DSOS254A-03C

Modification Recommended Service Note

DSOS254A – DSO Infiniium S Series 2.5GHz 4 channel

The Problem – Under certain circumstances a PLL2 error may occur on the S-series products.

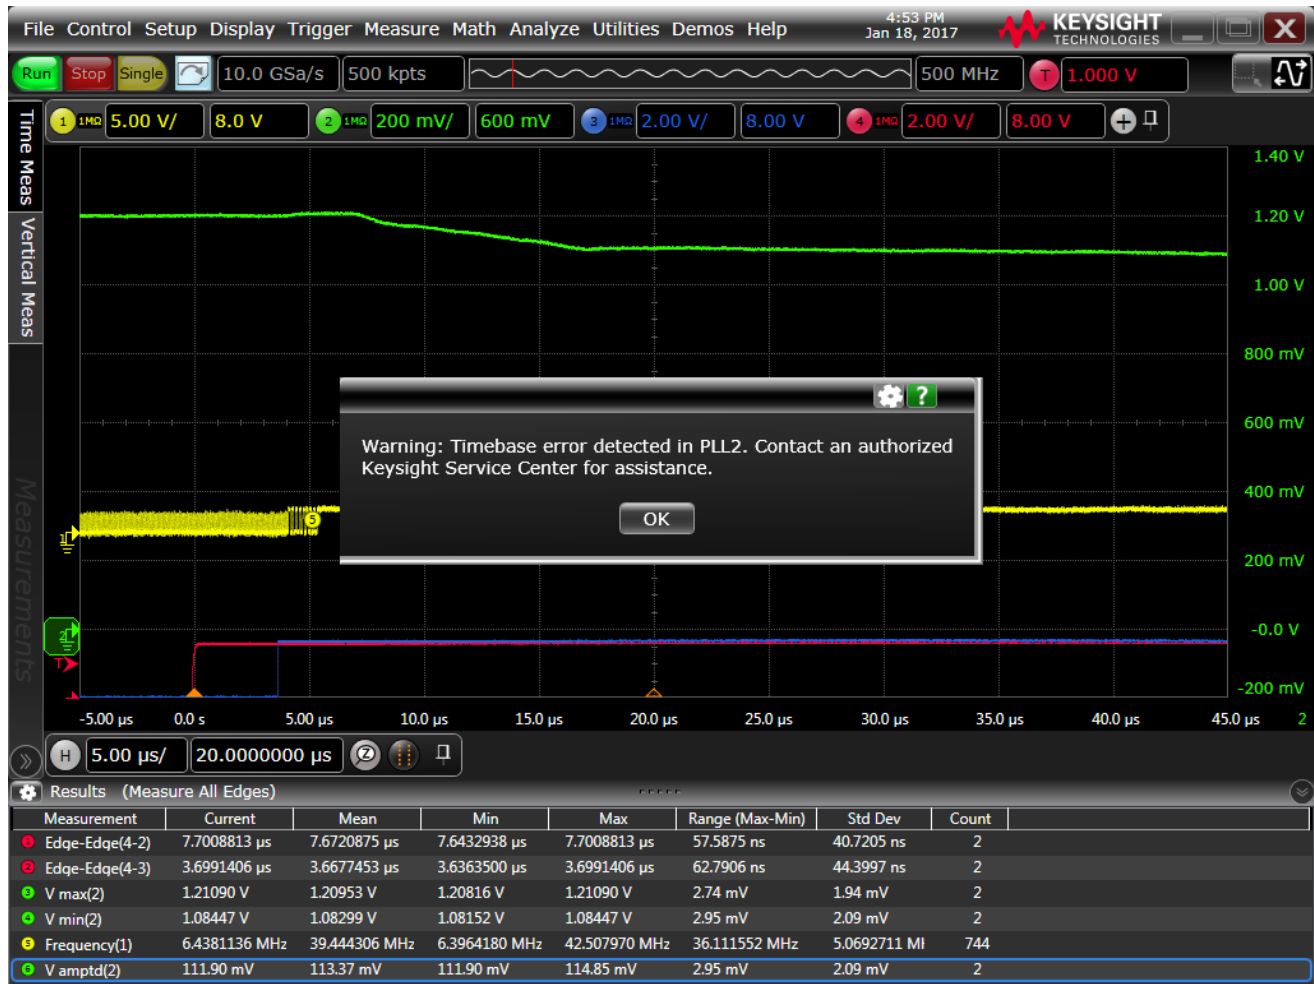
On older acquisition boards a PLL2 error message sometimes occurs. The error message appears on the screen as below:

There are new acquisition boards that fix this issue for the S-series scopes.

Please, use the 54911-69511 board until is gone.
